UNITED STATES PATENT AND TRADEMARK OFFICE

APPLICATION NO.	FILING DATE	FIRST NAMED INVENTOR	ATTORNEY DOCKET NO.	CONFIRMATION NO.
10/562,056	01/24/2006	Erkki Yli-Vakkuri	016050-080	4348

Office Action Summary	Application No. 10/562,056	Applicant(s) YLI-VAKKURI ET AL.	
	Examiner Erin Snelting	Art Unit 1791

DETAILED ACTION

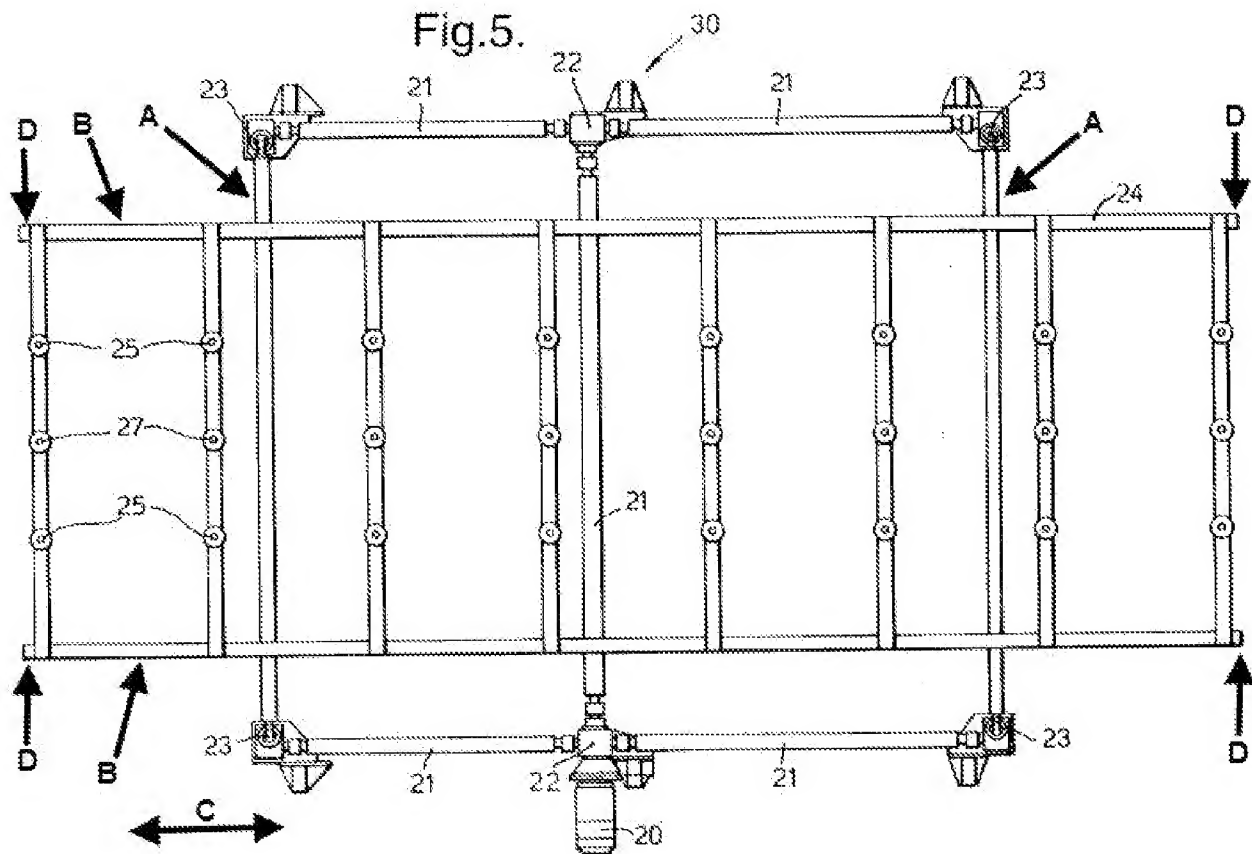
16. Regarding claim 4, Montonen '436 teaches frame, bearer elements, press-bending compartment as described for claim 1 above. Montonen '436 does not teach two elongated girders, which are disposed at a distance from each other underneath the bearer elements and whose ends are formed with flanges extending beyond side walls of the press-bending compartment, and longitudinal beams, each of which is fitted rigidly in a lengthwise direction of the furnace between two successive flanges. In analogous art of glass bending, Bennett '477 teaches (see examiner's references to Fig. 5, inserted below):

- a. two elongated girders (**A**) which are disposed at a distance from each other underneath the bearer elements ("lifting pins 25", column 7, line 53) and whose ends are formed with flanges ("screw jacks 23", column 7, line 52) extending beyond side walls ("furnace side walls 7 (FIG. 3)", column 6, line 31) of the press bending compartment ("A space 5 in the furnace", column 6, lines 29-30, see also Fig. 3)
- b. longitudinal beams (**B**, part of "frame 24", column 7, line 52), each of which is fitted rigidly ("The driveshafts operate lead screws of the screw jacks 23 upon which the frame 24 is mounted", column 7, lines 58-59) in a lengthwise

direction of the furnace (**C** – note that direction **C** is projecting into the plane of Fig. 3, and it is equivalent to direction “G” in Figs. 1, 2a, and 2b) between two successive flanges (**D**)

for the benefit of providing adequate and stable support for the mould carriage during the press-bending process, and also for positioning movement actuators outside of the press-bending compartment to simplify maintenance and so as not to expose the actuators to the heat of the compartment. Note that “flange” is interpreted as a projection formed to give additional strength, stiffness, or supporting area, or to provide a place for the attachment of other objects. It would have been obvious to one of
